## Review of Department of Defense Test Protocols for Combat Helmets

Committee on Review of Test Protocols Used by the DoD to Test Combat Helmets;  
Board on Army Science and Technology; Division on Engineering and Physical  
Sciences; National Research Council

FIGURE S-1 Operating characteristic curves for the Army's and the Director of Operational Test and Evaluation's first article testing protocols for penetration. The blue lines show the probabilities of acceptance for the two plans when the true probability of penetration is 0.1.

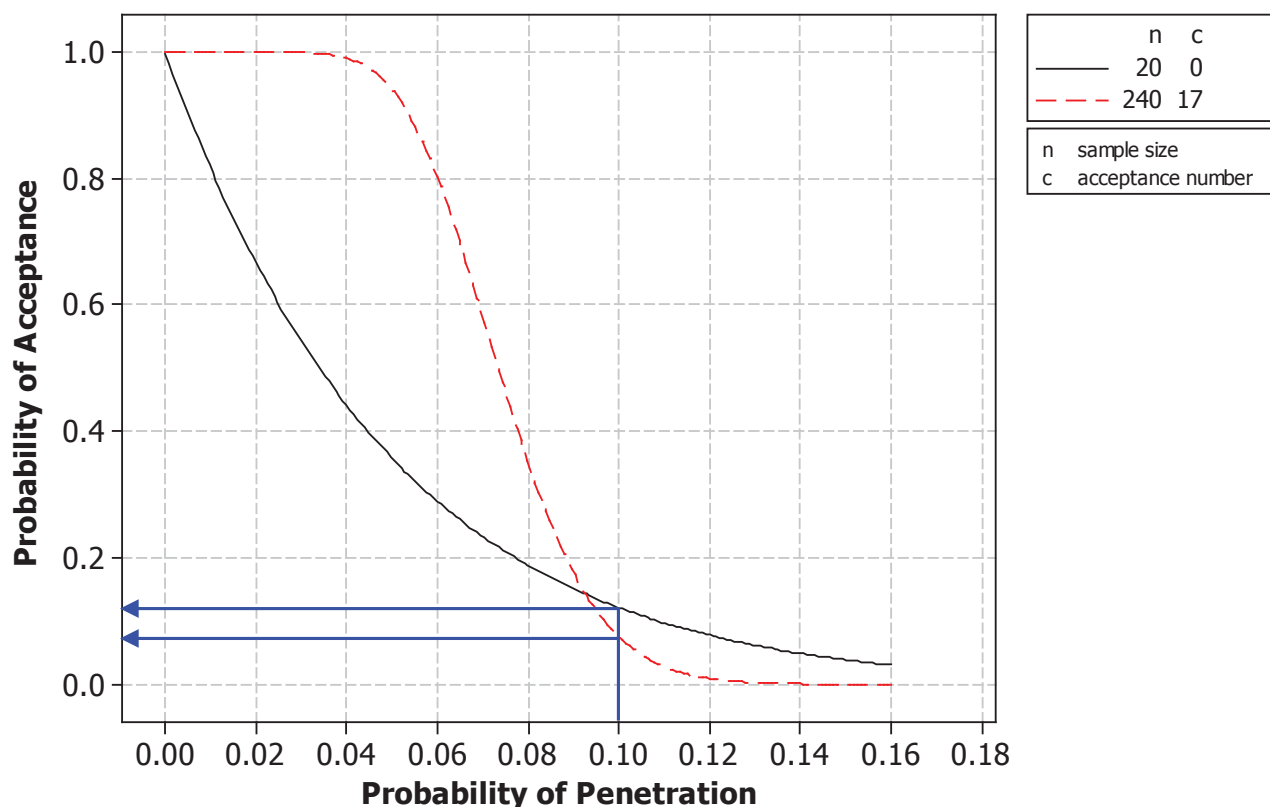
The properties of a test plan can be obtained from its operating characteristic (OC) curve, which is a plot of the probability of passing the test (y-axis) as a function of the penetration probability of a single shot (x-axis). The solid black curve in Figure S-1 gives the OC curve for the Army's 0-out-of-20 plan. The blue line shows that, if the true probability of penetration is 0.10, the probability of passing the test is about<sup>5</sup> 0.10. This property has been referred to as the

In developing its protocol, DOT&E decided to increase the number of helmets tested from 4 to 48. Five shots were taken at five different locations on a helmet (as was the case with the Army's protocol), leading to a total of  $n = 240$  shots. DOT&E applied the same 90/90 standard to get the number of acceptable penetrations as  $c = 17$ . In other words, the helmet design passes FAT if there are 17 or fewer penetrations in 240 shots and fails otherwise. The dashed red curve in Figure S-1 shows the OC curve for this plan developed by DOT&E. It can be seen that, if the true probability of penetration is 0.10, the probability of acceptance equals 0.10 (satisfying the 90/90 standard).

It is this change in the protocol, from zero penetrations (out of 20 shots) to allowing as many as 17 penetrations (out of 240 shots), that resulted in Rep. Slaughter's concern with the safety of Army combat helmets. In his response, Director Gilmore noted that DOT&E's plan had (essentially<sup>6</sup>) the same 90/90 property as the Army's legacy plan. Further, it had better statistical properties because a larger number of

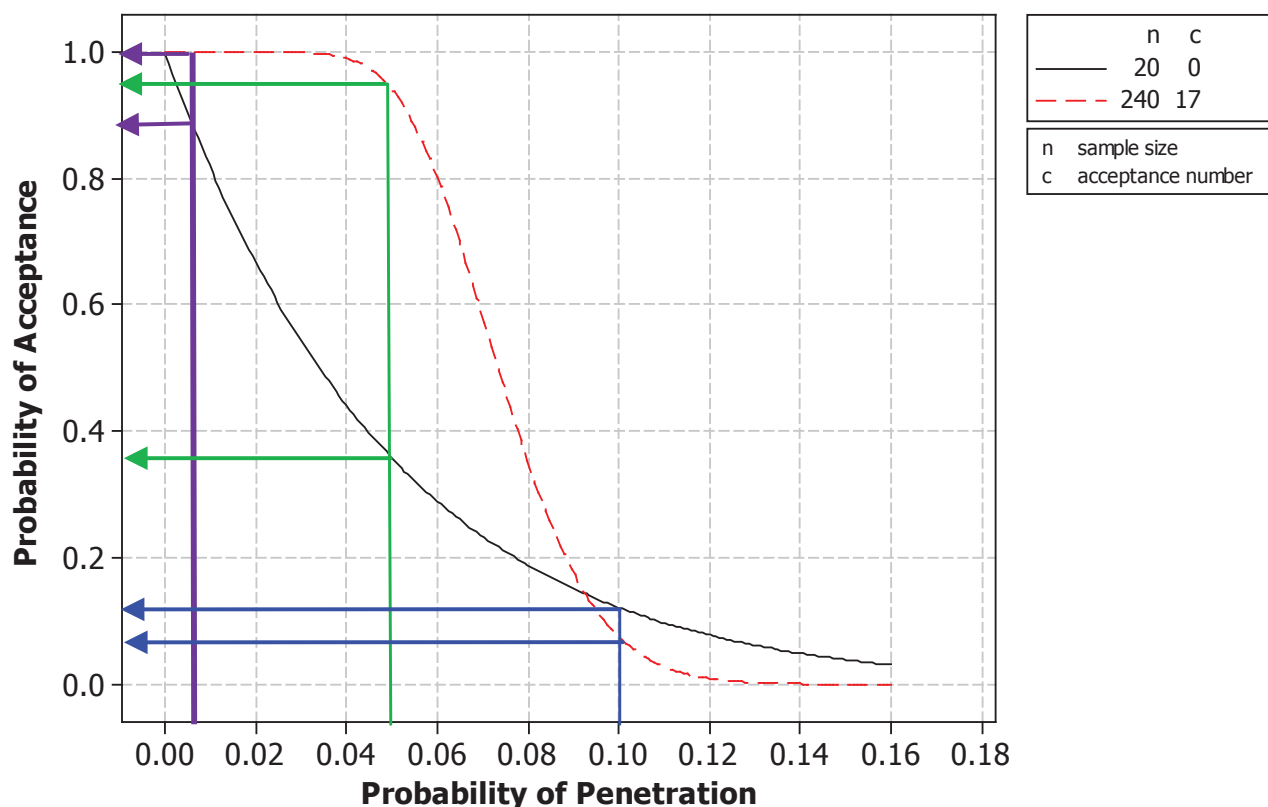
However, a key issue is whether the 90/90 standard, which was used to develop the protocol, is appropriate. In addition, that standard specifies only one point on the OC curve in developing the test plan, but, in fact, the whole curve and the plan's incentives and risks need to be considered. Figure S-2 provides a re-examination of the OC curves for the Army's and DOT&E's protocols. As in Figure S-1, the black curve is for the Army's 0-out-of-20 plan, and the red curve is for DOT&E's 17-out-of-240 plan. Each curve shows how the probability of accepting a helmet design (y-axis) varies as the underlying probability of penetration (x-axis) varies. As noted in Figure S-1, the two curves cross at a point close to penetration probability of 0.10 (blue line). To the left of this curve, DOT&E's plan (in red) has higher probabilities of acceptance (passing FAT); to the right it has lower probabilities. In other words, the DOT&E's plan is less stringent (easier to pass) than the original 0-out-of-20 plan if the actual penetration probability is less than 0.10 and more difficult to pass if the penetration probability is higher than 0.10. However, as we will see below, there are more pertinent penetration probabilities at which the plans should be compared.

Data made available to the committee show that manufacturers are currently producing ACHs with penetration probabilities around 0.005 or less (overall, there were 7 penetrations in 12,147 shots; see Chapter 5). This corresponds to the purple line in Figure S-2. At this penetration probability of 0.005, the probability of passing the FAT is close to 1.0 for DOT&E's protocol (red curve), while it is about 0.9 for the Army's legacy protocol (black curve). So the manufacturer's risks (probabilities of *not passing* the FAT) at a penetration probability of 0.005 are zero and 0.1 respectively. These are relatively small values, as they should be.

Consider the green line in Figure S-2 that corresponds to a penetration probability of 0.05, an order of magnitude higher than the current penetration level of 0.005. For this value, the DOT&E's plan (red curve), has an acceptance probability of about 0.95, while the Army's legacy plan (black curve) has a probability of about 0.38. In other words, if manufacturers produce helmets with a penetration probability of 0.05 (as noted, an order of magnitude higher than the current level), they have a 95 percent chance of passing the FAT under the current DOT&E protocol; that is, the government's risk is 0.95. In comparison, the government's risk under the Army's legacy plan is 0.38.

So the question comes down to the following: *What is the appropriate level of penetration probability at which the government's risk should be controlled?* By selecting the 90/90 standard, DOT&E has set this penetration probability at 0.10, a value that is roughly two orders of magnitude greater than where the manufacturers are currently operating.

**Recommendation 6-3.** The government's risk should be controlled at much lower penetration levels than the 0.10 value specified by the 90/90 standard.
